ADDENDUM

Addendum #03
TO PLANS AND SPECIFICATIONS FOR
ELEMENTARY SCHOOL (ES-23)

March 02, 2020

Project No.	Scale	
2019-0122		
Revision	VDQE #	Drawing No.
3	053-115-01-100	FA111

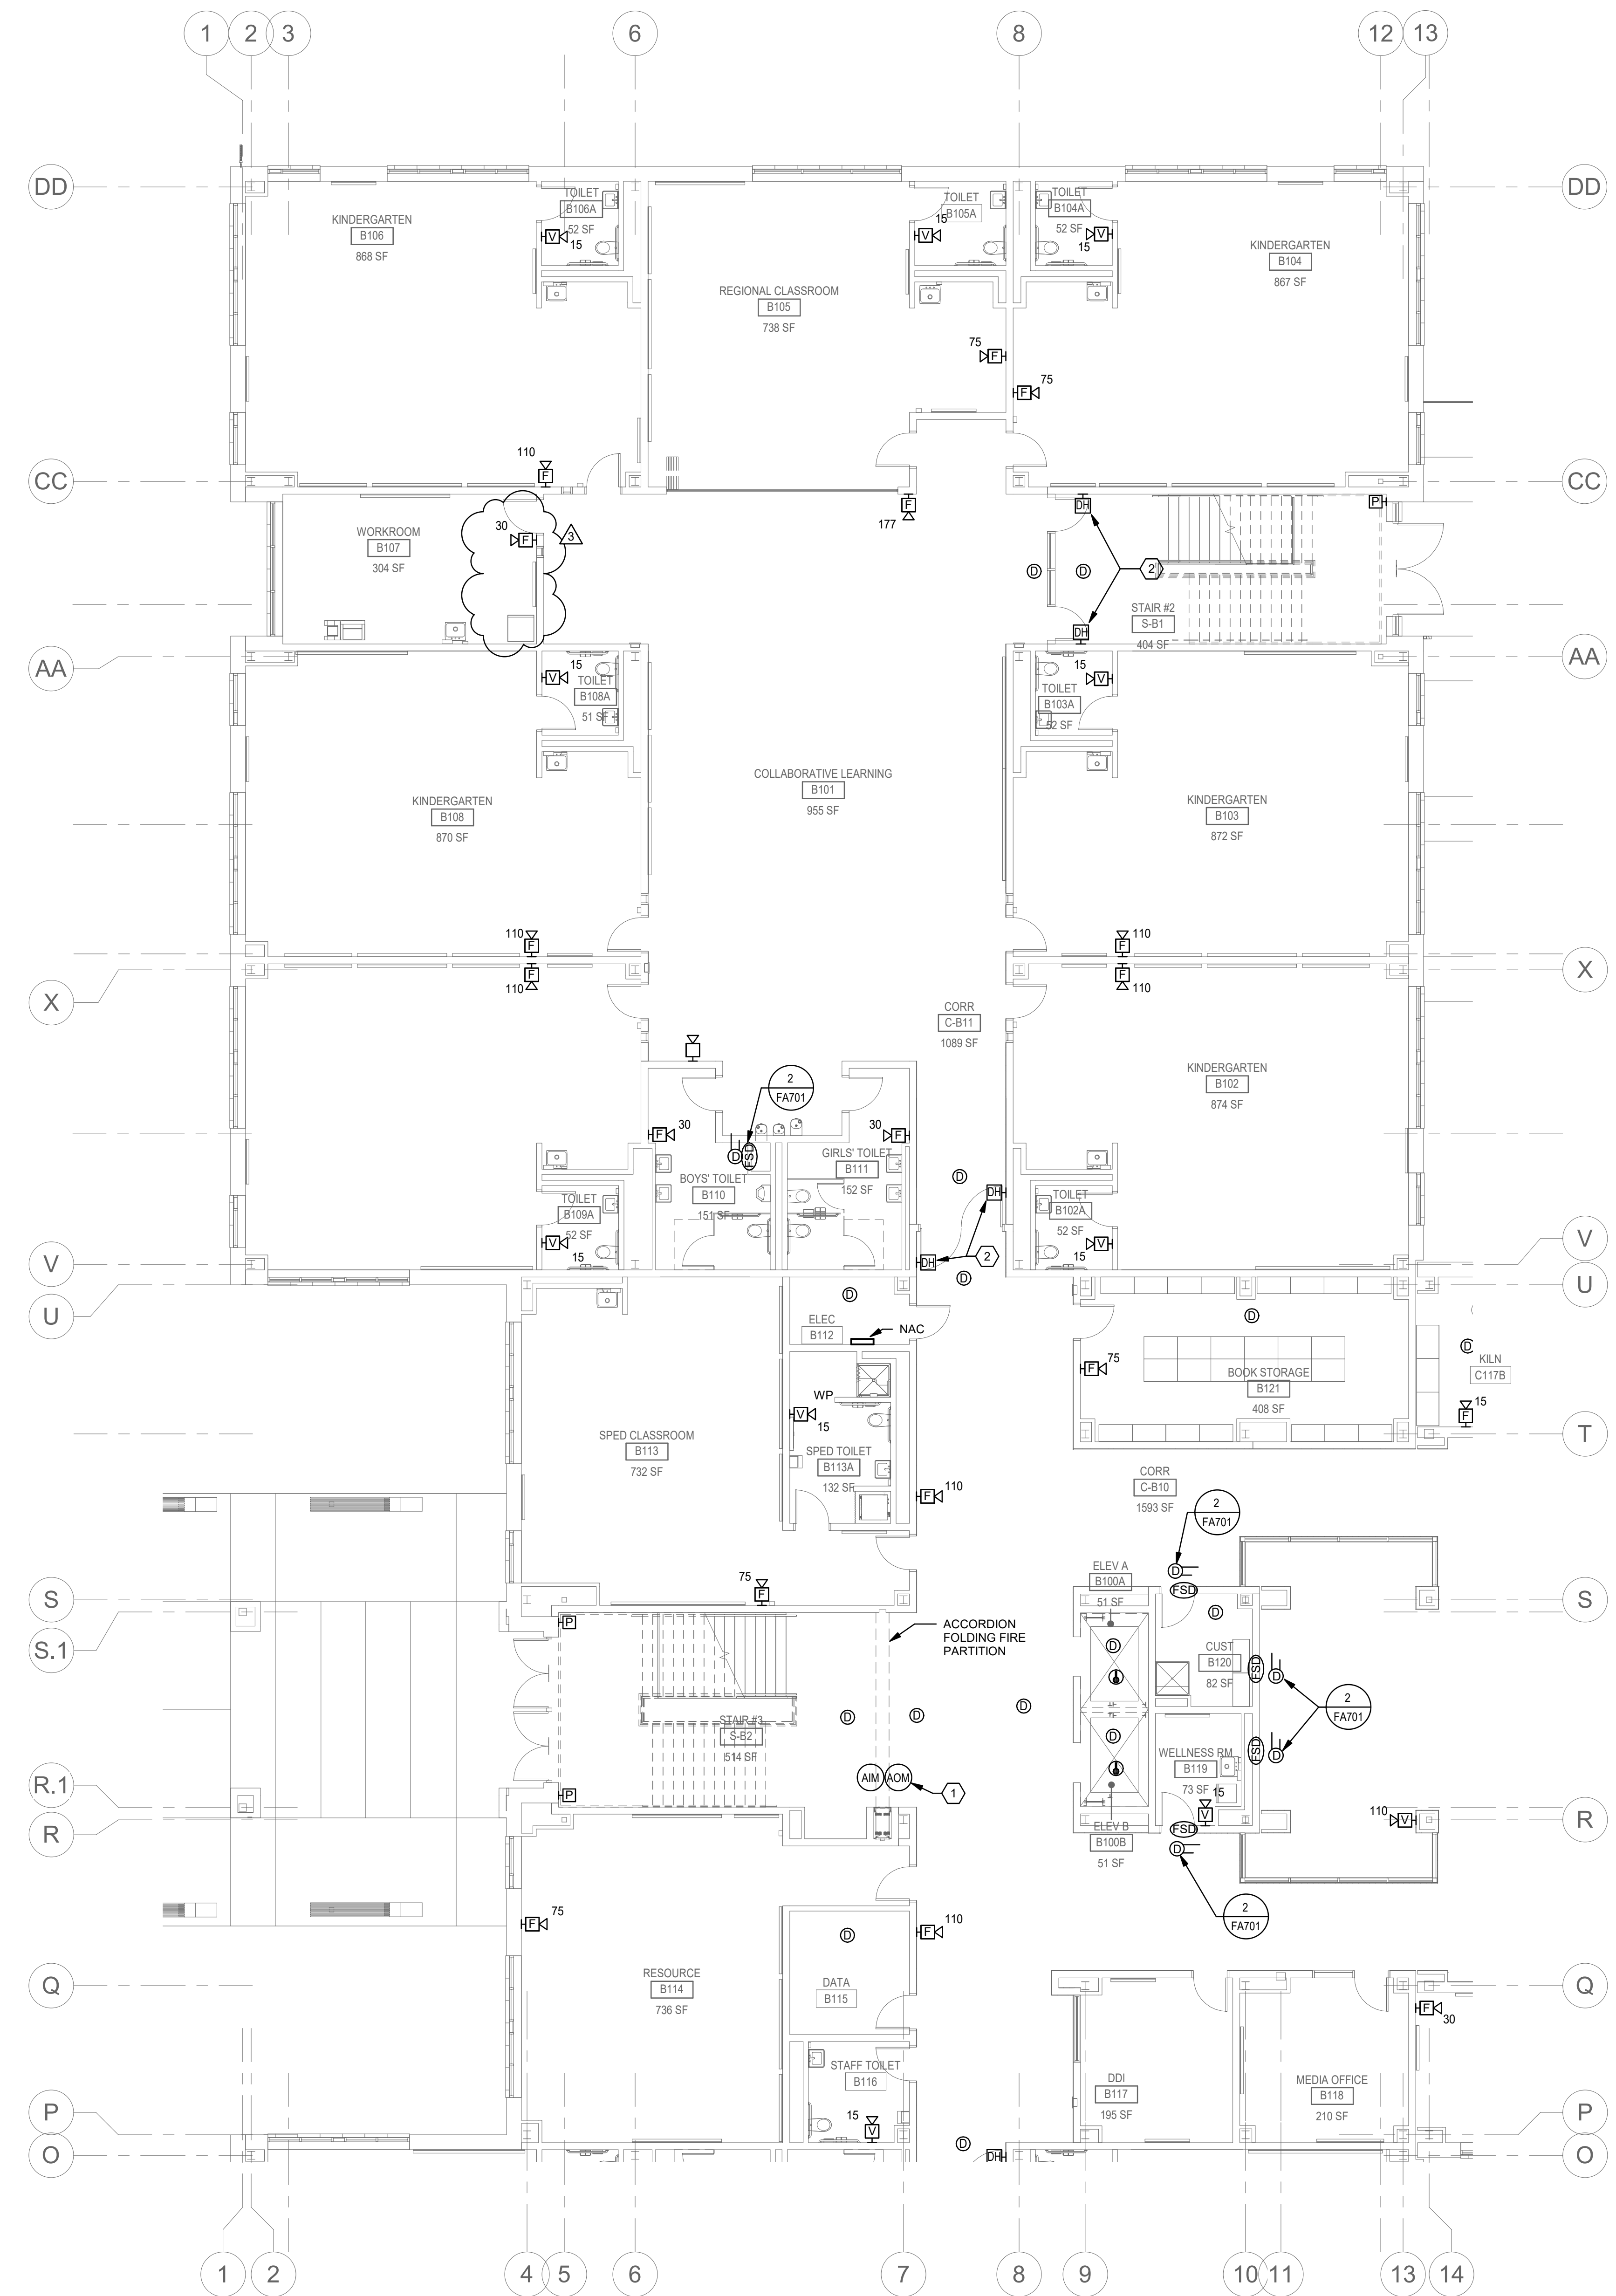
1. Sheet FA111:
 - Relocate speaker/strobe in A107 due to model change
2. Sheet FA112:
 - Relocate speaker/strobe in B107 due to model change
3. Sheet FA113:
 - Relocate speaker/strobe outside supply storage due to model change
4. Sheet FA121:
 - Relocate AORA call box and wheelchair outline in stair #1
 - Update keyed note
5. Sheet FA122:
 - Relocate AORA call box and wheelchair outline in stair #2
 - Update keyed note
6. Sheet FA131:
 - Relocate AORA call box and wheelchair outline in stair #1
 - Update keyed note
